**TOWNSHIP OF LAWRENCE**  
**Division of Planning and Redevelopment**

FROM:  Brenda Kraemer, Assistant Municipal Engineer

SUBJECT: Major Site Plan – Final Approval Application No. SP-2/23  
**RPM Development**, 2495 Brunswick Pike  
Tax Map Page 20.01, Block 2001, Lot 2.02

DATE: August 1, 2023

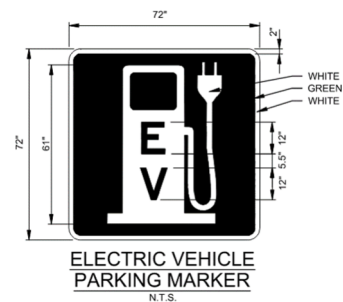
Per **Condition 22**, “For the crosswalk between the Property and the Lawrence Shopping Center, No Pedestrian Crossing (Symbol) and Use Crosswalk signs [(R9-3 & R9-3bp (L or R))] shall be installed on the pedestrian crossing. A raised pedestrian crosswalk shall be provided. *Applicant responded “The enclosed site plan drawings have been revised to provide ‘No Pedestrian Crossing’ and ‘Use Crosswalk’ signs at the pedestrian crossing to the Lawrence Shopping Center.”* **Condition Open. Please remove ‘R9-3BL signs’ as shown in the plans. Moreover, the crosswalk is shown incorrectly as ‘painted’, not raised as outlined in the Condition. Necessary revisions should be made.**

Per **Condition 23**, “On the Final Site Plan, all signs on the Property shall be called out by their MUTCD designation (current sheet 5 of 17). Additional signs will be needed at and for the Property driveway. A No Outlet sign (W14-2) shall be installed on the east island the east end of the rear parking space row. On the west end of the parking row, a No Parking Any Time sign (R7-1) shall also be provided.” *The Applicant responded “The enclosed site plan drawings have been revised to provide MUTCD designations for proposed signage. Additionally, a ‘No Outlet’ sign has been provided on the end island at the east end of the rear parking space row. A ‘No Parking Anytime’ sign has been provided on the west end of the rear parking space row.”* **Condition Open. The Van Accessible Plaque is mislabeled as R7-8a instead of MUTCD designation R7-8P (P for Plaque). The Penalty Plate is also mislabeled as R7-8P, instead R(NJ)7-8A per the New**

**Jersey Sign Manual.** The R9-3A as shown in the plan is incorrect, it should be R9-3. Moreover, sign R9-3BR (MOD) is incorrect, it should be R9-3bP (L or R) per MUTCD. No Outlet Sign Detail ‘W14-2’ is missing. The correct sign details those should be included in the plans are presented below for reference.

Per **Condition 26**, “Within the ADA Parking Sign on Bollard detail, the Penalty Plate shall be changed to reflect a size of 10” x 12”.” *Applicant responded, “The enclosed site plan drawings have been revised to reflect a Penalty Plate size of 10” x 12” on the ADA parking sign detail.”* **Condition Satisfied. However, see Condition 23 above for corrections to the sign designations.**
